Access Compliance Report

Public Rights-of-Way

(Curb Ramps)

Intersection ID: 28390	Main Street: ARDREY_KELL_RD	Cross Street: BRIDGEHAMPTON_CLUB_DR	Location: E
ADA ID: 8AEE7DAB1FD0	Ramp Type: BlendTrans1	Initial Pass/Fail: Fail	Overall Compliance: No
		Severity Score: 17.5

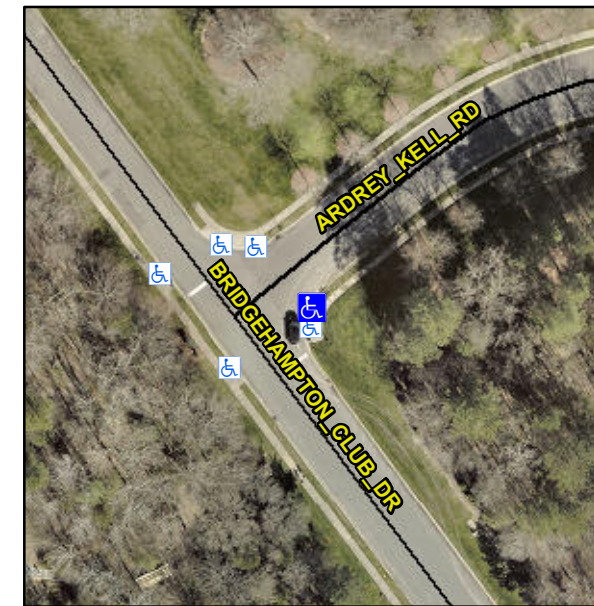
Not Found, R304.5.1

Compliance	Description	Data	Compliance	Description	Data
N/A	Ramp Length (in)	47.5	Yes	BlendTrans Slope (%)	3.5
No	Ramp Width (in)	33.5	Yes	BlendTrans XSlope (%)	1.7
N/A	Flare Type LT	N/A	N/A	Flare Type RT	N/A
N/A	Flare Slope LT (%)	N/A	N/A	Flare Slope RT (%)	N/A
N/A	Flare Traversable LT?	N/A	N/A	Flare Traversable RT?	N/A
N/A	Landing Length (in)	N/A	N/A	DWS Provided?	N/A
N/A	Landing Width (in)	N/A	N/A	DWS Contrast?	N/A
N/A	Landing Slope (%)	N/A	N/A	DWS Length (in)	N/A
N/A	Landing X Slope (%)	N/A	N/A	DWS Full Width?	N/A
N/A	Landing Curb? (Y/N)	N/A	N/A	DWS Offset (in)	N/A
N/A	Shared Landing?	N/A			
N/A	Gutter Ponding?	N/A	N/A	Gutter Slope (%)	N/A
N/A	Gutter Lip Ht (in)	N/A	N/A	Gutter X Slope (%)	N/A
N/A	Painted X Walk1?	No	N/A	Painted X Walk2?	N/A
	X Walk 1 Direction	To NW		X Walk 2 Direction	N/A
	X Walk 1 Width (in)	N/A		X Walk 2 Width (in)	N/A
	X Walk 1 Slope (%)	N/A		X Walk 2 Slope (%)	N/A
	X Walk 1 X Slope (%)	N/A		X Walk 2 X Slope (%)	N/A

N/A	Ramp inside XWalk1?	N/A	N/A	Ramp inside XWalk2?	N/A
	Road Slope (%)	N/A		Clear Space?	N/A
	Road X Slope (%)	N/A	N/A	Clear Space to XWalk (in)	N/A
N/A	Any Obstructions?	N/A	N/A	Storm Grate/Utility Hazard?	N/A
	Obstruction Type			Storm Grate/Utility Type	
		N/A			N/A
			Yes	Surface Condition? (G/P)	Good
			No	Curb Slope (%)	17.9

Remove & Replace Curb Ramp With Two New Directional Ramps or Equivalent.
